Access Compliance Report

Public Rights-of-Way

(Curb Ramps)

Intersection ID: 20622	Main Street: SANDY_PORTER_RD	Cross Street: TARAGATE_DR	Location: SE
ADA ID: A752E6731DBF	Ramp Type: Directional1	Initial Pass/Fail: Fail	Overall Compliance: No
Severity Score: 21.25			
Codes/Mitigation Info/Possible Solution		Field Measurements/Component Compliance

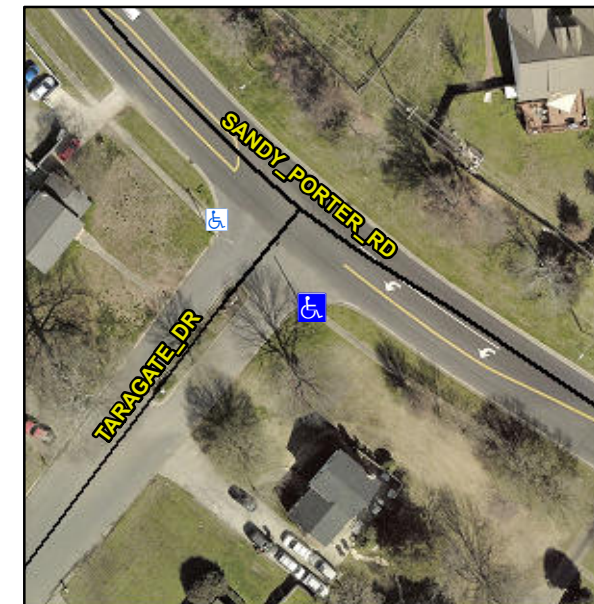
R304.5.1, R304.2.2

Compliance	Description	Data	Compliance	Description	Data
N/A	Ramp Length (in)	48.0	N/A	Grade Break?	N/A
No	Ramp Width (in)	42.0	N/A	Grade Break Slope (%)	0.0
No	Ramp Slope (%)	8.6	N/A	Grade Break XSlope (%)	0.0
Yes	Ramp XSlope (%)	1.2			
N/A	Flare Type LT	N/A	N/A	Flare Type RT	N/A
N/A	Flare Slope LT (%)	N/A	N/A	Flare Slope RT (%)	0.0
N/A	Flare Traversable LT?	N/A	N/A	Flare Traversable RT?	N/A
N/A	Landing Length (in)	0.0	N/A	DWS Provided?	N/A
N/A	Landing Width (in)	0.0	N/A	DWS Contrast?	N/A
N/A	Landing Slope (%)	0.0	N/A	DWS Length (in)	N/A
N/A	Landing X Slope (%)	0.0	N/A	DWS Full Width?	N/A
N/A	Landing Curb? (Y/N)	N/A	N/A	DWS Offset LT (in)	N/A
N/A	Shared Landing?	N/A	N/A	DWS Offset RT (in)	N/A
N/A	Gutter Ponding?	0.0	N/A	Gutter Slope (%)	N/A
N/A	Gutter Lip Ht (in)	0.0	N/A	Gutter X Slope (%)	N/A
N/A	Painted X Walk1?	No		Road Slope (%)	6.9
	X Walk 1 Direction	To NW		Road X Slope (%)	2.9
	X Walk 1 Width (in)	N/A		Clear Space?	N/A

Remove & Replace Entire Ramp.
